Access Compliance Report Public Rights-of-Way (Curb Ramps)

Main Street: NEWPORT_BLV **Cross Street:** E_SKYLARK_PL **Location:** W

ADA ID: RPRK211012144218 **Ramp Type:** Type 4 - Parallel **Initial Pass/Fail:** Fail **Overall Compliance:** No **Severity Score:** 15

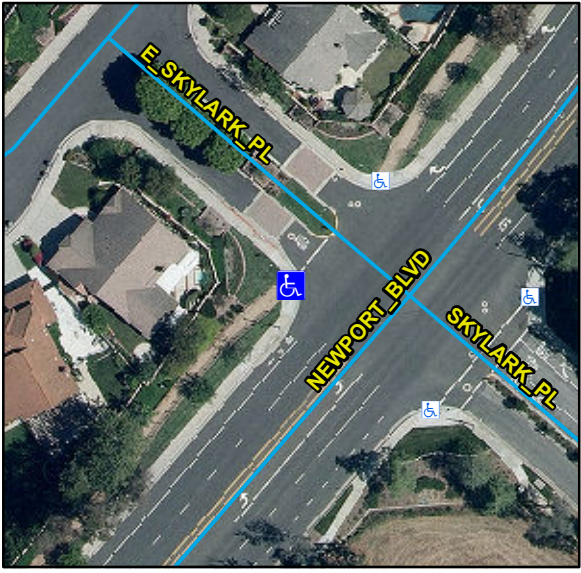
Compliance	Description	Data	Compliance	Description	Data
N/A	Ramp Length LT (in)	135	N/A	Ramp Length RT (in)	114
Yes	Ramp Width LT (in)	80	Yes	Ramp Width RT (in)	77
No	Ramp Run Slope LT (%)	10.9	Yes	Ramp Run Slope RT (%)	2.5
Yes	Ramp Cross Slope LT (%)	1.1	Yes	Ramp Cross Slope RT (%)	0.2
N/A	Landing Present	N/A	N/A	DWS Provided	N/A
N/A	Landing Length (in)	N/A	N/A	DWS Contrast	N/A
N/A	Landing Width (in)	N/A	N/A	DWS Length (in)	N/A
N/A	Landing Run Slope (%)	N/A	N/A	DWS Full Width	N/A
N/A	Landing Cross Slope (%)	N/A		DWS Offset Type	N/A
N/A	Landing Movement Obstructed?	N/A	N/A	DWS Offset Left (in)	N/A
	Landing Movement Type	N/A	N/A	DWS Offset Right (in)	N/A
N/A	Landing Shared	N/A			
N/A	Clear Space	Yes			
N/A	Clear Space To Crosswalk (in)	N/A			
N/A	Marked Crosswalk 1	No	N/A	Marked Crosswalk 2	No
	Crossing 1 Direction	SE		Crossing 2 Direction	NE
N/A	Marked Crosswalk 1 Width (in)	N/A		Marked Crosswalk 2 Width (in)	N/A

Possible Solutions:
Remove & Replace Curb Ramp With Two New Directional Ramps or Equivalent.

OC Std/PROW:
R304.3.2, STD 1115
